PROPOSAL FOR DRAFT AMENDMENTS TO REGULATION No. 52

Corrigendum to document TRANS/WP.29/GRSG/2002/6

(Transmitted by the Expert from Germany)

"Figure 7

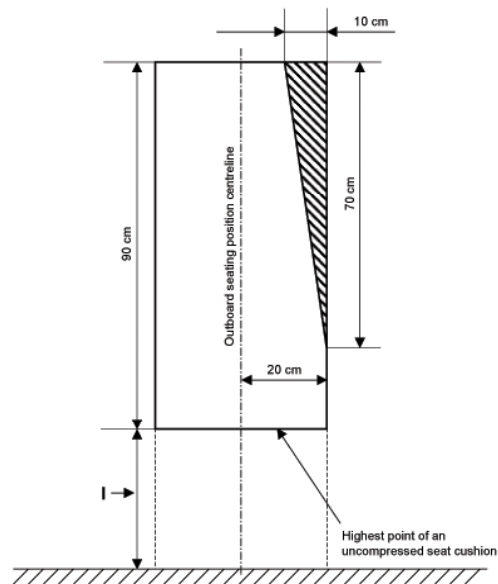
Paragraph 5.7.8.1.3.2., amend to read:

"5.7.8.1.3.2. Intrusion of a structural member provided that the intrusion is included within a triangle whose peak is situated ~~65 cm from the floor~~ **70 cm from the top** and whose base is 10 cm in width and situated in the upper part of the space in question, adjacent to the side wall of the vehicle (see annex 3, figure 7)."

Annex 3, figure 7, amend to read:

I (cm) min.
40-50
(35 cm at wheel arches and engine compartment)

The alteration corrects figure 7.

The requirements of figure 14: I (cm) min 40 - 50 (35 cm at wheel arches and engine compartment) are transferred to figure 7 to make it clear that the general prescriptions of paragraph 5.7.8.3. apply also to paragraph 5.7.8.1.3.2.

As there are different values for "I" the former method to define the starting point for the triangle representing the permitted intrusion needs to be revised, in order to establish equal conditions for all of the different values. This is achieved by measuring from the top of the minimum height above the seat and leaving the geometry of the triangle unchanged.
